Access Compliance Report

Public Rights-of-Way

(Pedestrian Signals)

Intersection ID: N/A	Main Street:	Cross Street: N/A	Location: N/A
ADA ID: B7C8AEFDF97A	Signal Type: One Push Button-APS	Overall Compliance: No	Severity Score: BTN 1: N/A BTN 2: N/A No BTN: N/A
Codes/Mitigation Info/Possible Solution		Field Measurements/Component Compliance

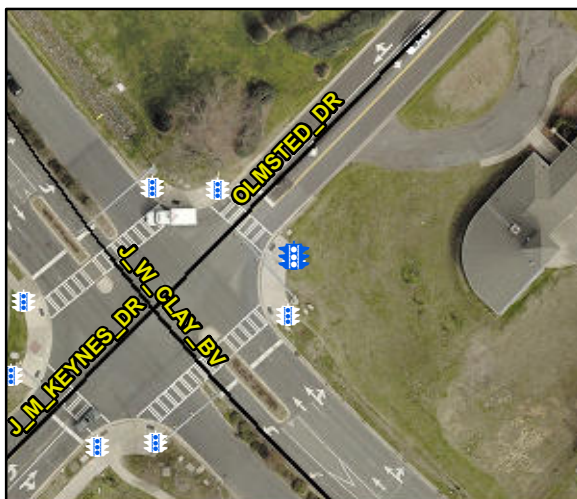
Surveyor Notes: NOT HOOKED UP, NOISES AND VERBAL COMMANDS UNKNOWN

N/A	B 1 Clear Xing Direction?	Yes	N/A	B 2 Clear Xing Direction?	N/A
	B 1 Crossing Direction	To NW		B 2 Crossing Direction	N/A
Yes	B 1 DistanceTo XWalk (in)	32.0	N/A	B 2 DistanceTo XWalk (in)	N/A
No	B 1 DistanceTo Curb (in)	122.0	N/A	B 2 DistanceTo Curb (in)	N/A
Yes	B 1 Diameter (in)	2.0	N/A	B 2 Diameter (in)	N/A

Possible Solutions: Replace Signal Push Button With APS Button on New Post. Remove & Relocate Sign.
